## RESPONSE TO AUDIT ISSUES

### APR1400 Topical Reports

Review Section	TR Realistic Evaluation Methodology for LBLOCA of the APR1400
Application Section	Topical Report: APR1400-F-A-TR-12004 Realistic Evaluation Methodology for Large-Break LOCA of the APR1400
Issue Date	08/13/2015

### **Audit Issues No. 20**

Figure 1. Total Nitrogen Gas Release Rate from Four SIT-FDs

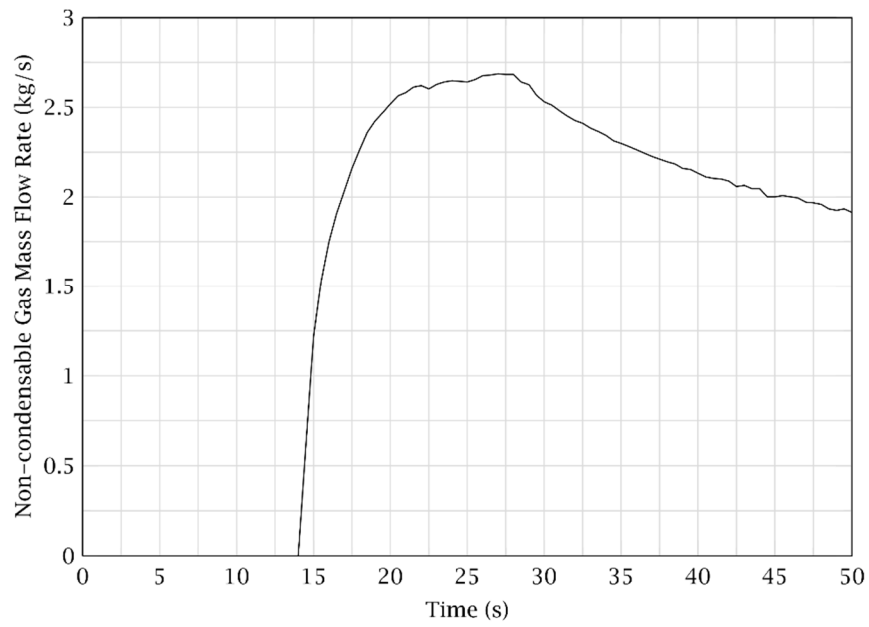
The guidance in RG 1.157, Section 2.1.2 establishes acceptable controls for the calculation of the effects of noncondensable gases in best estimate analysis. In addition, NUREG/CR-5249 (pg. 68) explicitly addresses the bias due to dissolved nitrogen. The RELAP5/MOD3.3 code does not model dissolved nitrogen in the liquid and therefore, the predicted reflood peak cladding temperature does not reflect its effect. An assessment and documentation of the effect of dissolved nitrogen on the PCT is needed.

Figure 1 shows the total dissolved nitrogen gas release rate from four SIT-FDs. The peak mass flow rate of dissolved nitrogen is about 2.7 kg/s, and this value exceeds the maximum value of Reference [1] as described above. This is intended to demonstrate the apparent effect of dissolved nitrogen on ECCW bypass.
